Humboldt County Resource Conservation District Russ Creek & Centerville Slough Restoration Project

Addendum #2

3 PLAN DETAIL - WALL INTERCONNECTION WEST SIDE
1" = 1'-0"

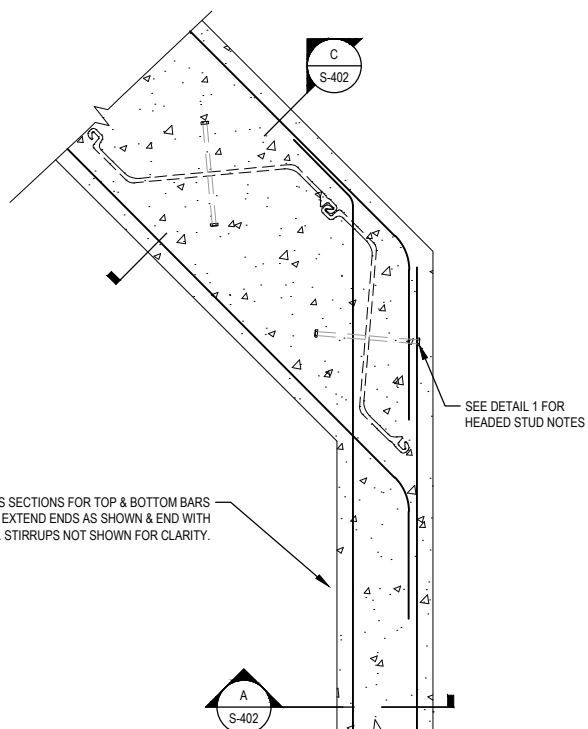
Item 1. QUESTION: NZ22 sheet piles are specified throughout the structural plans (S-302, S-402), while S-502 Detail 5 calls for NZ14 at the west wall interconnection, with no properties provided. Additionally, S-102 shows sheet piles as not interconnected, conflicting with S-502 DETAIL 1, 4, and 5 which shows the sheets being interconnected. Please confirm the required sheet pile type at the interconnection, and whether interconnection is intended.

RESPONSE AND REVISION: The NZ14 sheet pile callout in Detail 5 on Sheet S-502 is incorrect and has been revised to NZ22, consistent with Sheets S-302 and S-402. NZ22 sheet piles are required at all locations. Regarding interconnection, the sheet piles shown on Sheet S-102 beneath the culvert are foundation piles installed at a lower elevation, while the sheet piles adjacent to the wingwalls are installed at a higher elevation. These sheets are not intended to be interconnected due to the difference in elevation. Refer to Sheet S-302 for elevations. Sheet piles installed in the same plane and elevation, such as along a continuous wingwall, are intended to be interconnected in accordance with the manufacturer's instructions. Detail 5 on Sheet S-502 is a typical detail illustrating interconnection where required for constructability and does not apply to all conditions shown on the project.
